To: Marcia Spencer-Famous
From: Dana Valteau, TRC
Subject: DP 4860 Kibby Expansion, Response to MNAP Comment,
as Transmitted via E-mail February 24, 2010
Date: April 8, 2010
CC:

TransCanada
 Kibby Expansion
 15 WTG Layout
 April 1, 2010

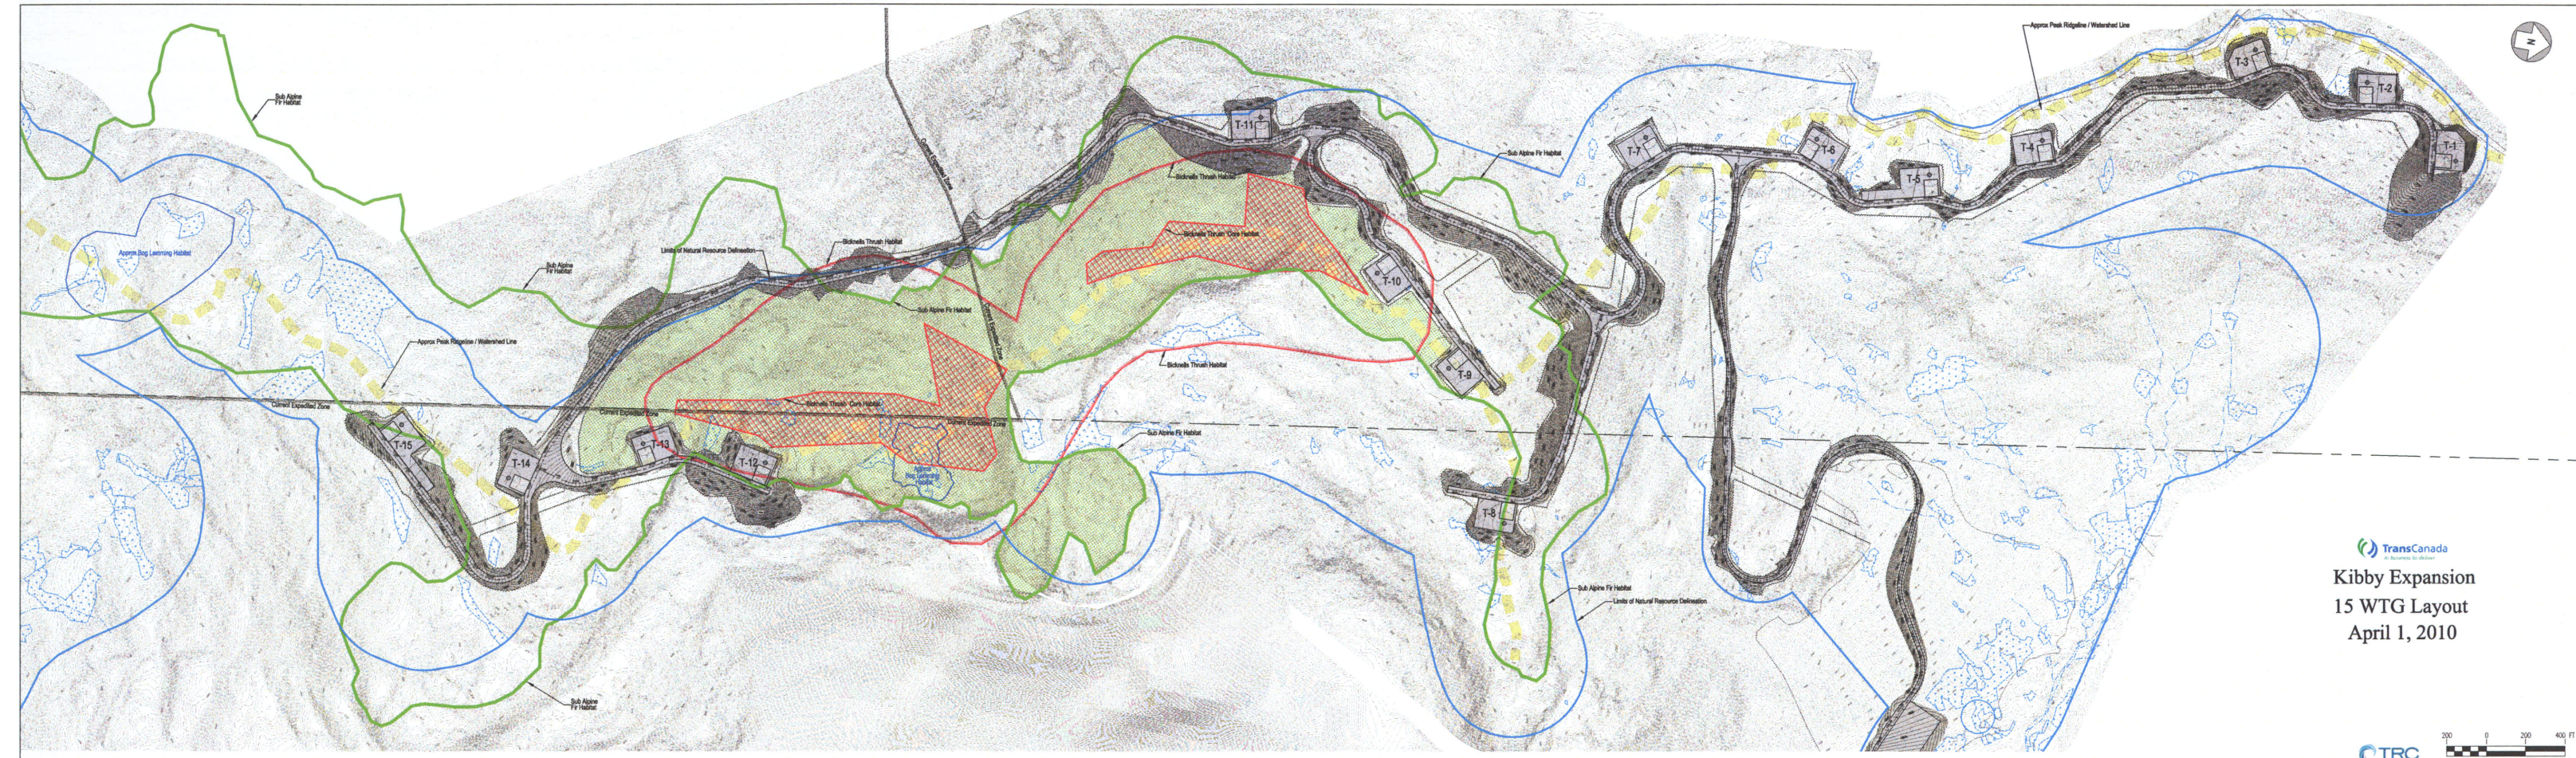
As currently designed, Turbine 11 effectively fragments the remaining core of the northern portion of the Fir – Heart-leaved Birch Sub-alpine Forest into two smaller areas. Removal of Turbine 11 would considerably decrease impacts to the Fir – Heart-leaved Birch Sub-alpine Forest and result in a northern core of approximately 62 contiguous acres. The removal of Turbine 11 reduces the impact from 80 to 75 acres but considerably reduces fragmentation of the remaining northern portion of the natural community. If a wind powered electric generation facility is approved for construction on this site the project plan should specifically demonstrate how the facility has been designed to cause the least impact to sensitive plant and animal habitat, and the development plan should address each of the following considerations in the design, construction, and management of the facility:

In response to MNAP and MDIFW comments, TransCanada has moved Turbine 11 to the west and downslope from the originally proposed site reducing both impact and fragmentation to the Subalpine Fir Forest. See the attached layout map. In general, this project has been designed to reduce overall footprint to the minimum needed to support the proposed project. The LURC application describes the planning and design work in Exhibit B.13. Road width has been reduced to the amount minimally necessary for equipment used during construction to 34 feet on the ridges and 20 feet on access roads. Materials for road and crane pad construction for this project will come from the project site, and will not require additional clearing or removal of other materials from other than areas within the project disturbed area. Cut/fill for the project is also close to a balance, which means minimal materials will be required from outside of the project footprint. In other words, for the most part only the area and those earthen materials that need to be used for construction of the project will be disturbed. During operation, ridge road widths will be effectively reduced to 20 feet by applying erosion control mulch that has been manufactured on site from native materials to the edges of the roads as well as to the majority of the area of turbine pads used during construction but which are not
